Design Team Name Concrete Jungle Consulting not comply with

CEE 4730/6730 Design project grading checklist-Phase I Green Roof Load and Moment Analysis Fall 2020. Due 5:00 PM, Friday, September 3, 2021
Hard-copy submittal in binder unless notified otherwise. (Lots of binders in Hollister basement.)

CORNELL ENGINEERING STUDENT CENTER
FOOTPRINT PLAN VIEW

2.6

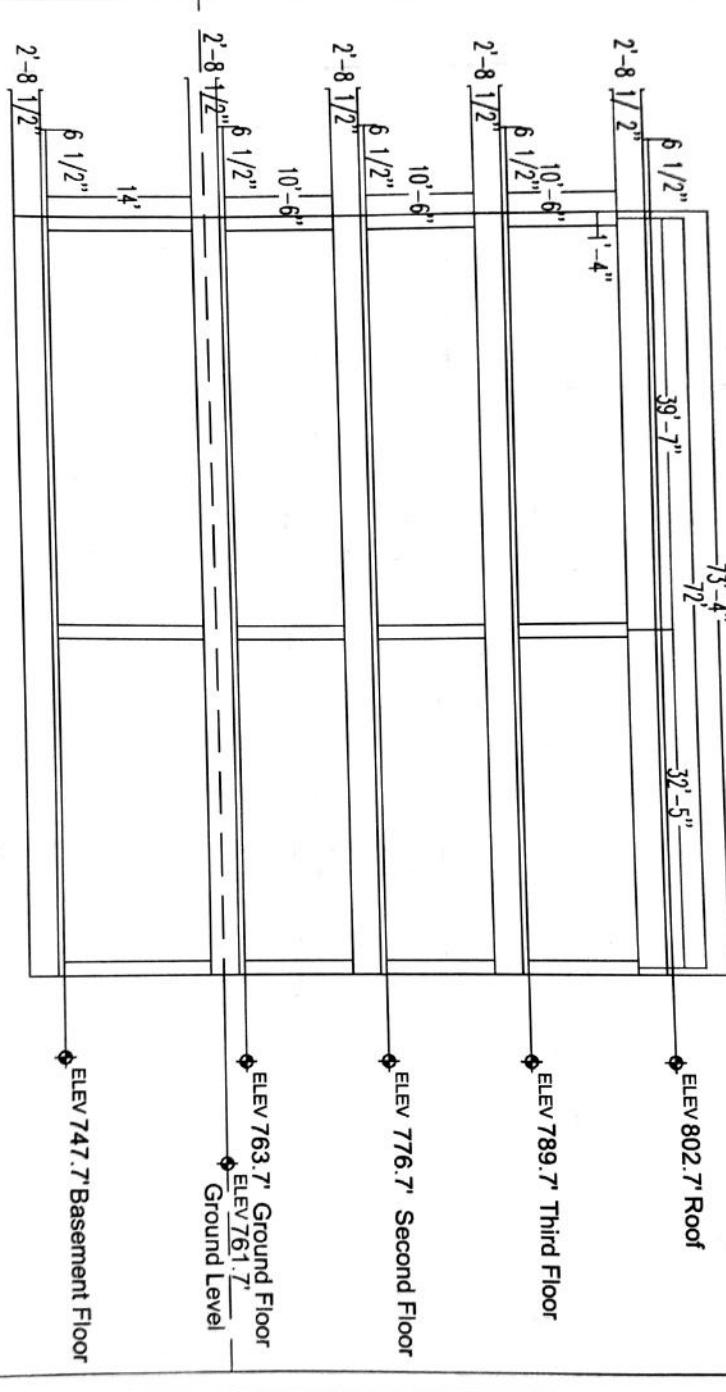
2.4	A scale drawing of your proposed multi-layer green roof system with notes to identify each component.	5	
2.5	An elevation view of the building showing all floors and foundation (looking from the south or north side). (May be combined with 2.3)	5	Not scale drawing.

DRAWING TITLE: ELEVATION VIEW OF THE GRID SYSTEM OF TYPICAL FLOOR LAYOUT

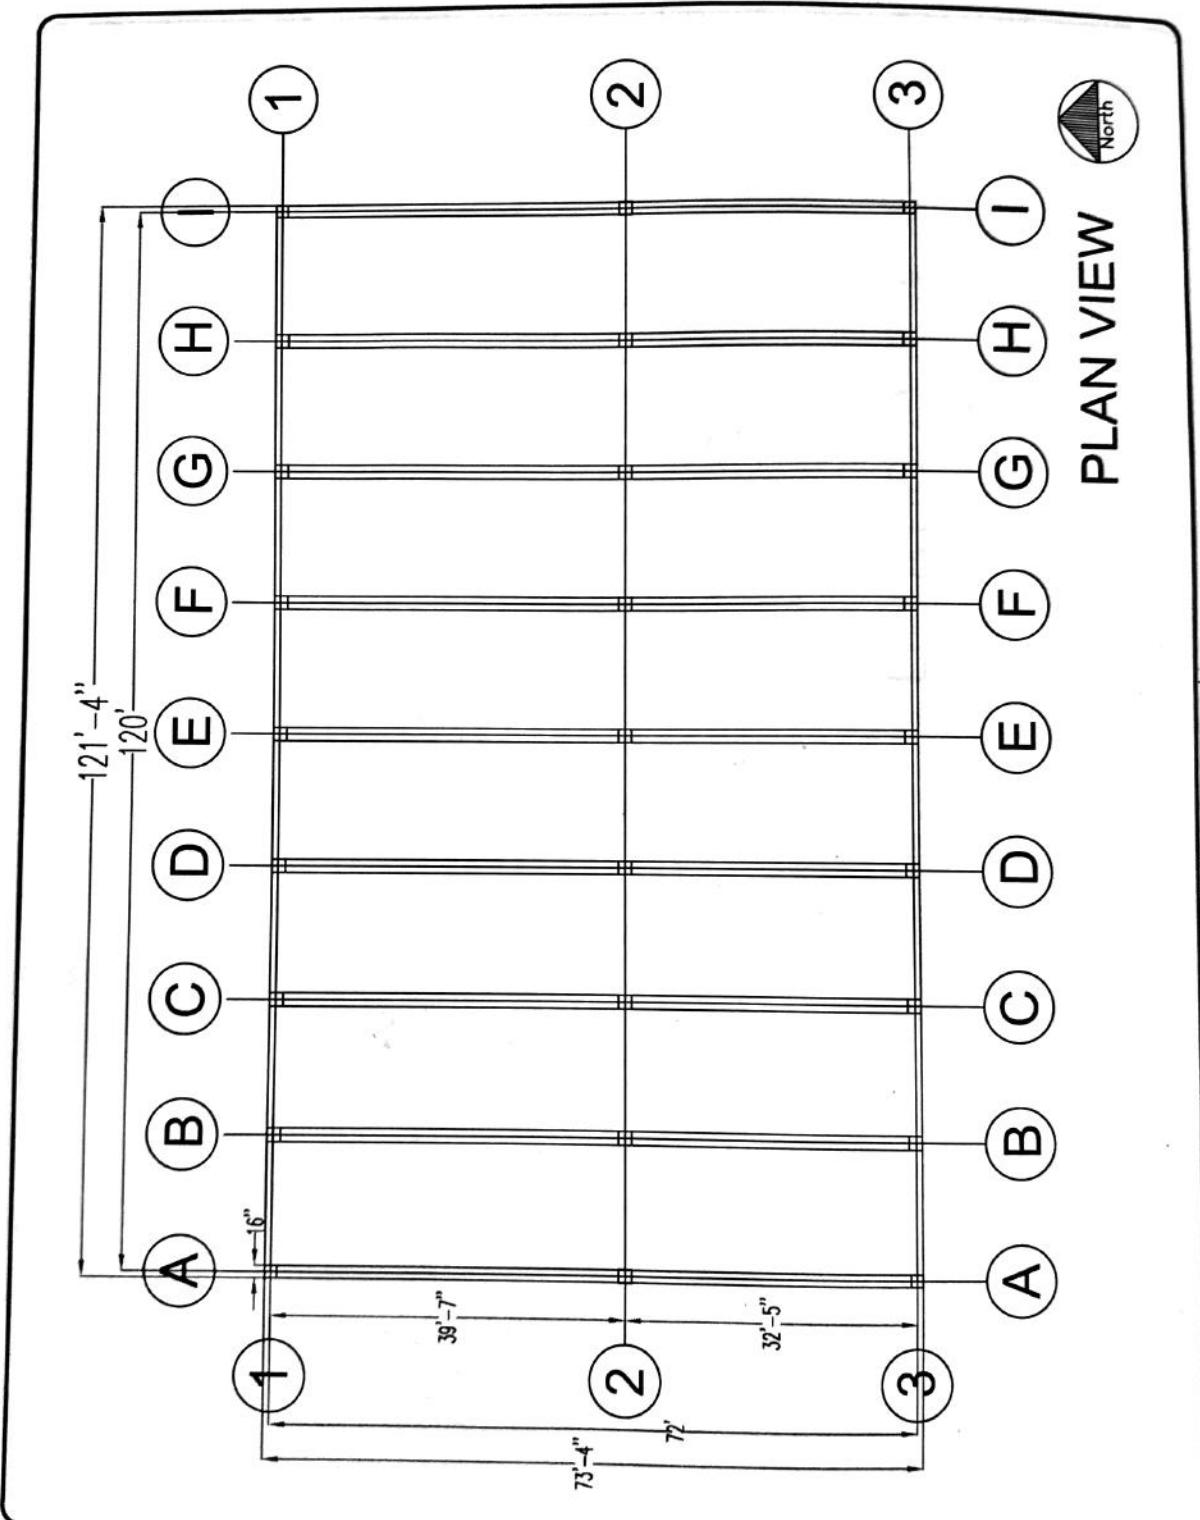
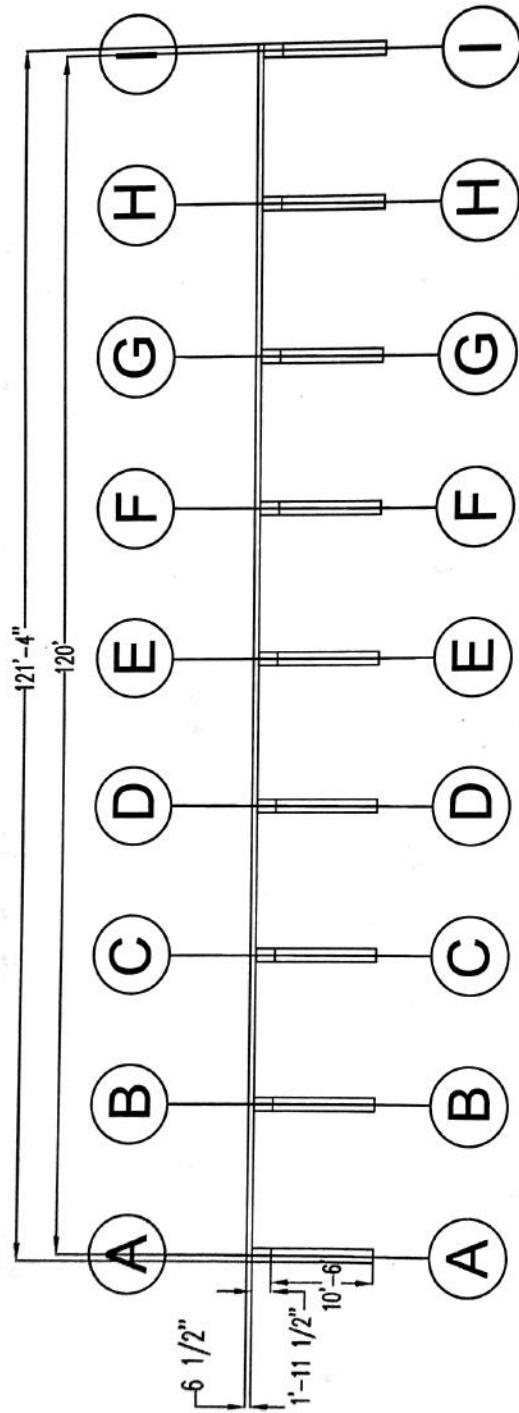
slab span dims?

Please use even scales

DRAWING TITLE: OVERALL REBAR DIAGRAM

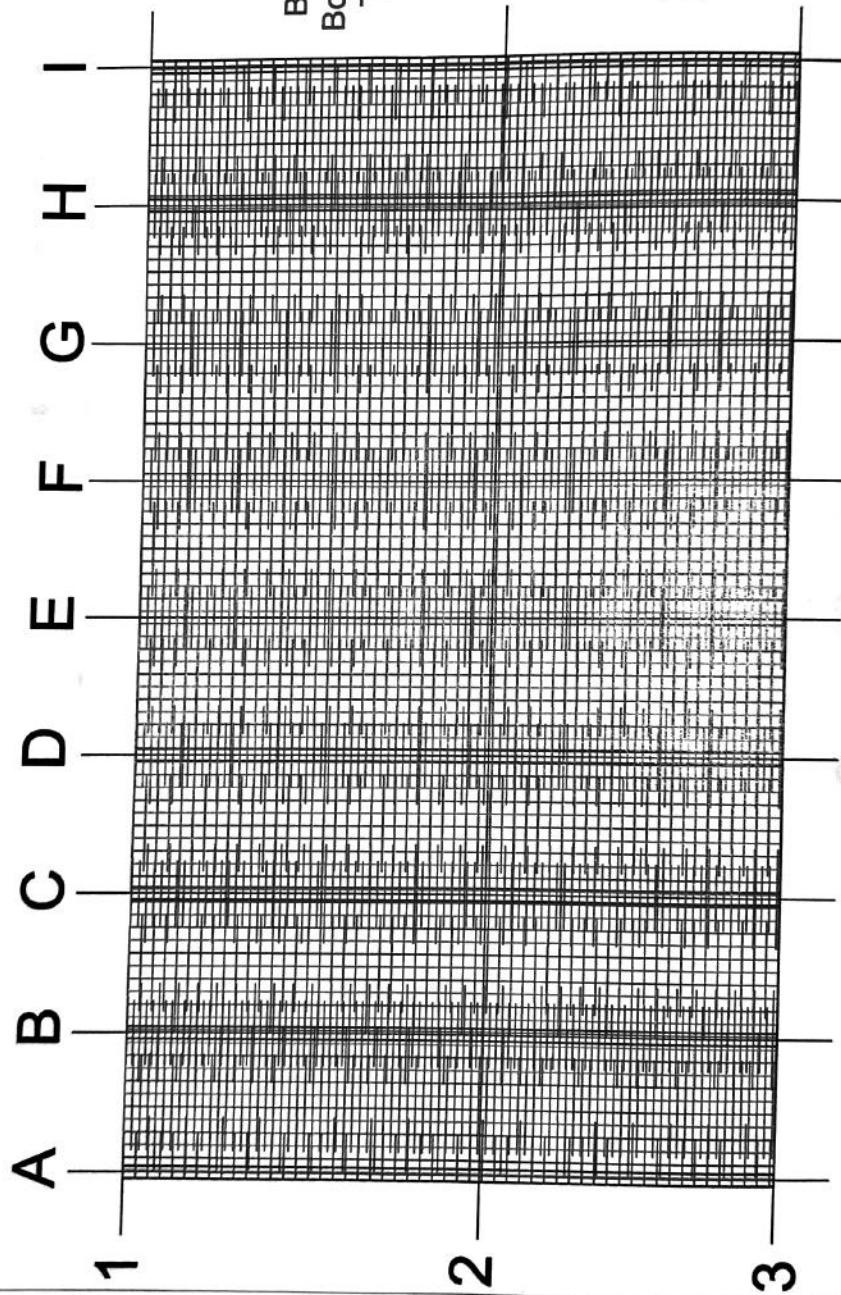
do not show all bars in the same view. This is very hard to read.

section 2.5.1

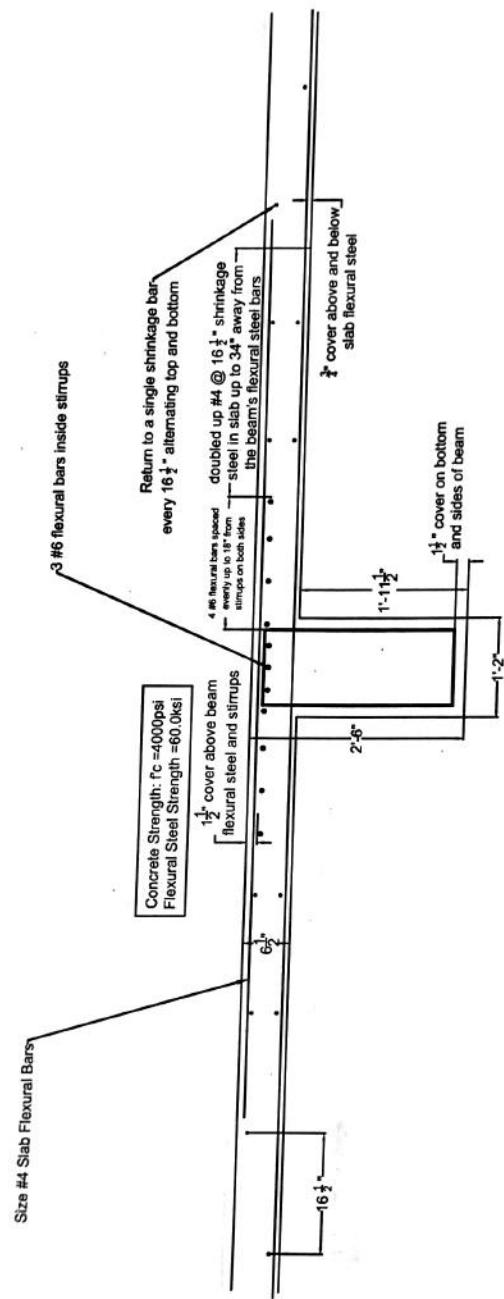
- ↳ Shear steel strength (0.5)
- ↳ Inconsistent number of bars for beam (0.5)
(You had 5 in previous drawing)

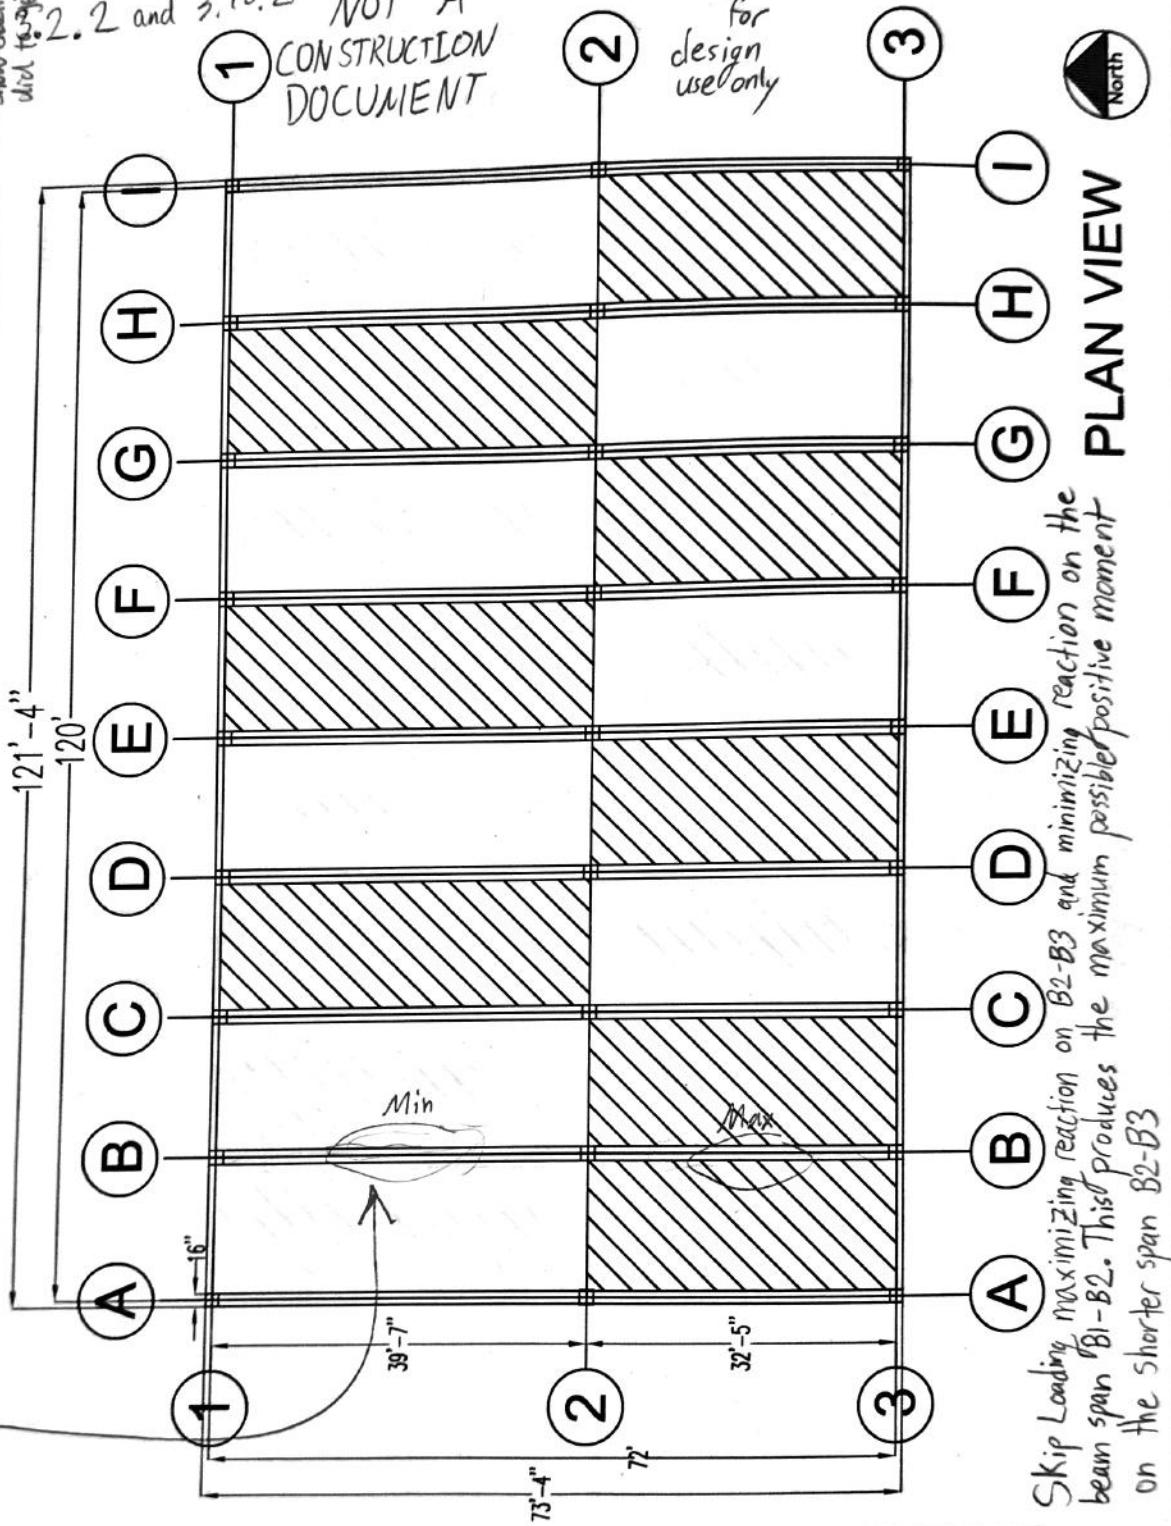
"Inverting" the skip loading for one long span slab actually produces a lower reaction on B1-B2 than if none of the long span slabs had live load.

Then don't skip loading on long spans.
Show exactly what you did to get the max.

Section 3.3.2 # 317

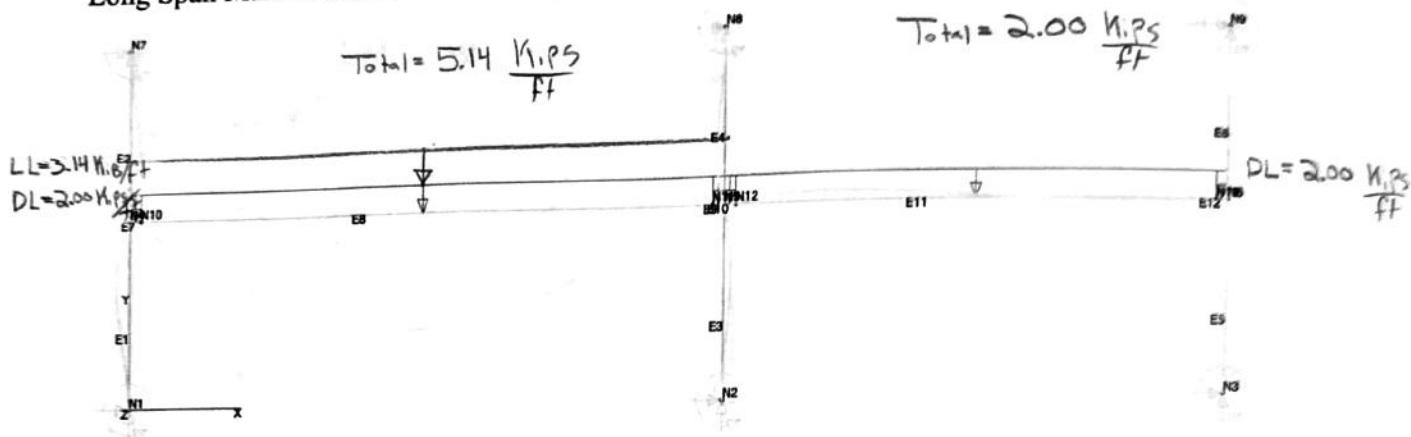
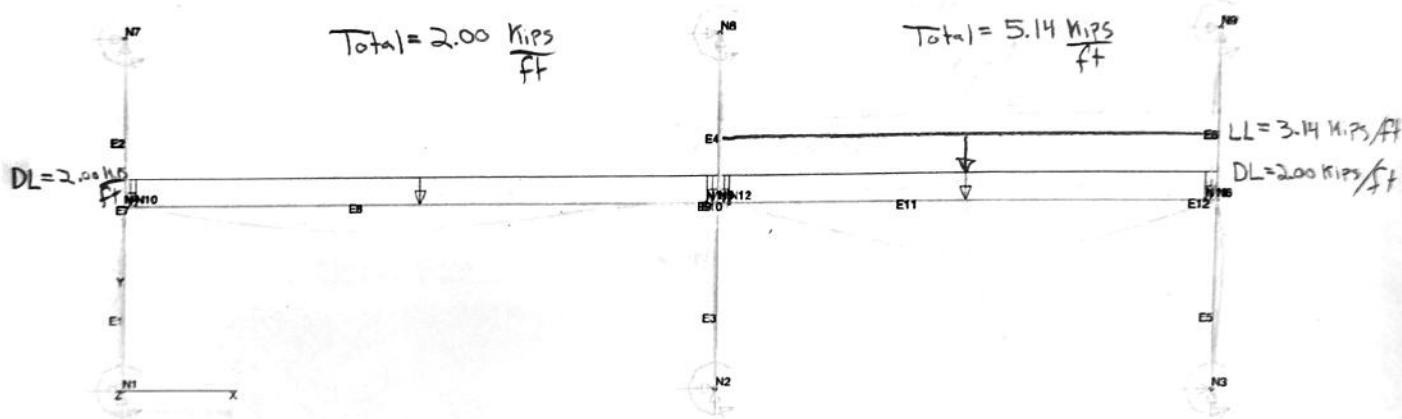
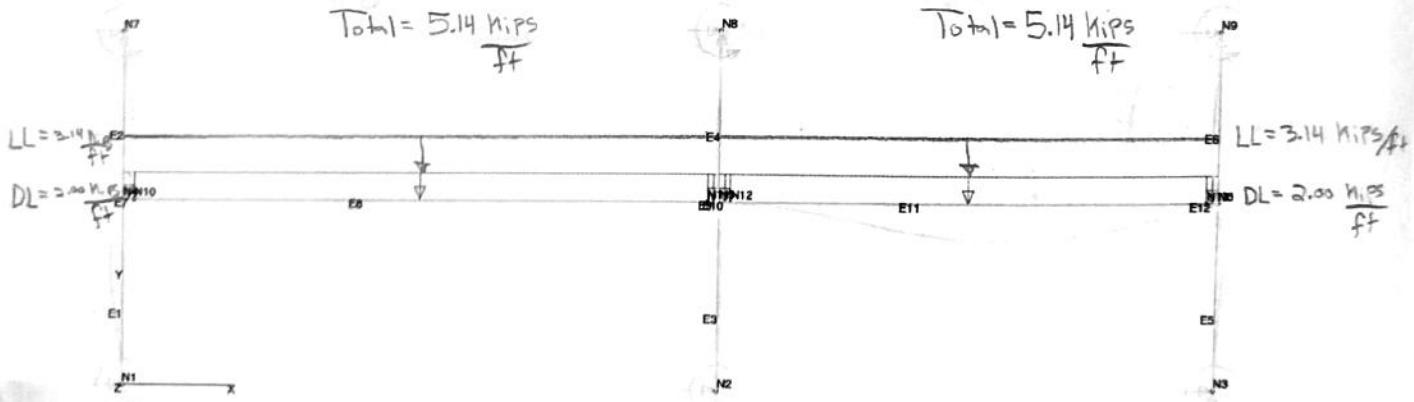
* What's the "column" length in your MASTAN Model? 18" x 18"

& Calculation of CG for beam sections not shown.
